Document C802.16d-04/55 - Bob Nelson

Resolution of Comments 167-170:

Figure 1—Maximum time relevance of DL-MAP and UL-MAP(TDD)

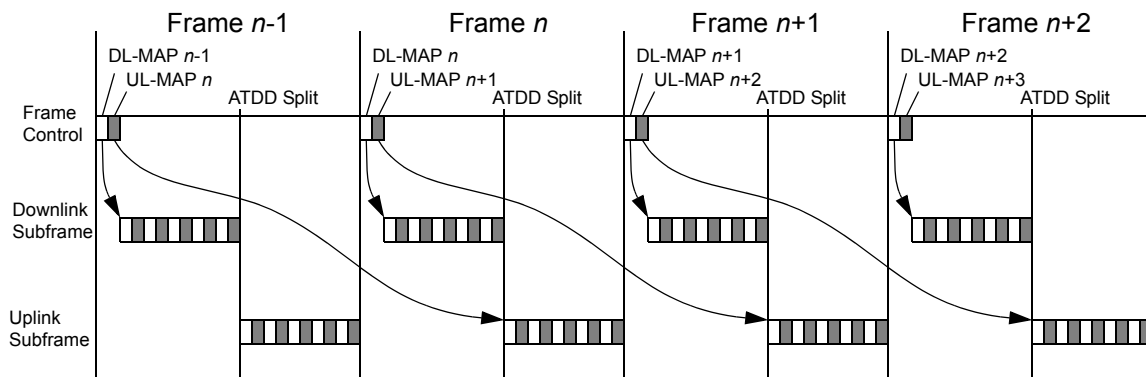
Information in the DL-MAP pertains to the current frame (the frame in which the message was received). Information carried in the UL-MAP pertains to a time interval starting at the Allocation Start Time measured from the beginning of the current frame and ending after the last specified allocation. This timing holds for both the TDD and FDD variants of operation. The TDD variant is shown in Figure 1 and Figure 2. The FDD variant is shown in Figure 3 and Figure 4.
